# UNITED STATES PATENT AND TRADEMARK OFFICE

APPLICATION NO.	FILING DATE	FIRST NAMED INVENTOR	ATTORNEY DOCKET NO.	CONFIRMATION NO.
10/779,366	02/13/2004	Arkady Kantor	22177-0019-C2	7901

## Office Action Summary

Figs. 1, 2 & 3 – Dental X-ray Apparatus – U.S. Patent 4,157,476

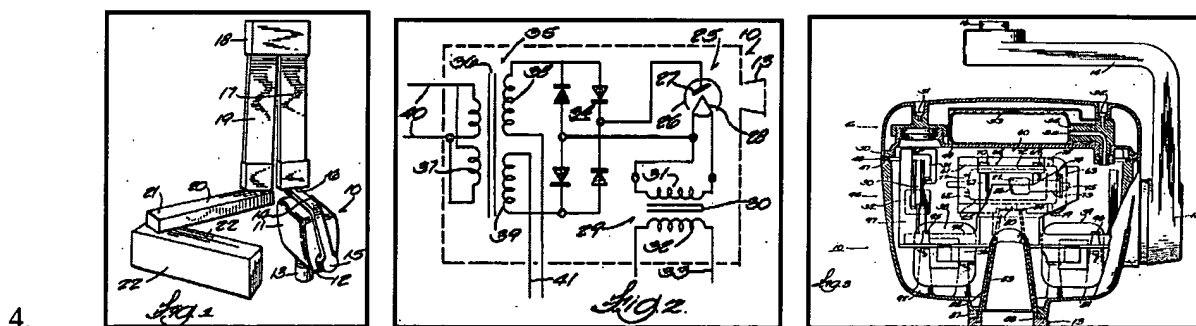
5. U.S. Patent 4,157,476 teaches that a conventional dental tubehead (10) comprises a housing (11), a collimator (80), an x-ray tube (25), high-voltage circuitry including one or more high-voltage transformers (see Fig. 2 above), dielectric oil (column 1, lines 10-11) and a tube holder (60) to support the x-ray tube.

6. It would have been obvious to one having ordinary skill in the art at the time the invention was made to modify the apparatus of U.S. Patent 6,945,694, such that it incorporated a tubehead comprising a housing, a collimator, a x-ray tube, high-voltage circuitry including one or more high-voltage transformers, dielectric oil and a tube holder to support the x-ray tube, wherein the collimator, the x-ray tube, the high voltage circuitry and the tube holder are disposed in the housing and soaked in dielectric oil. One would have been motivated to make such a modification for the purpose of generating collimated X-ray radiation from a generating means, while reducing thermal build-up within the device by exposing internal components to heat transfer means as dielectric oil, as is suggested by U.S. Patent 4,157,476 and current practice within the X-ray radiation art.
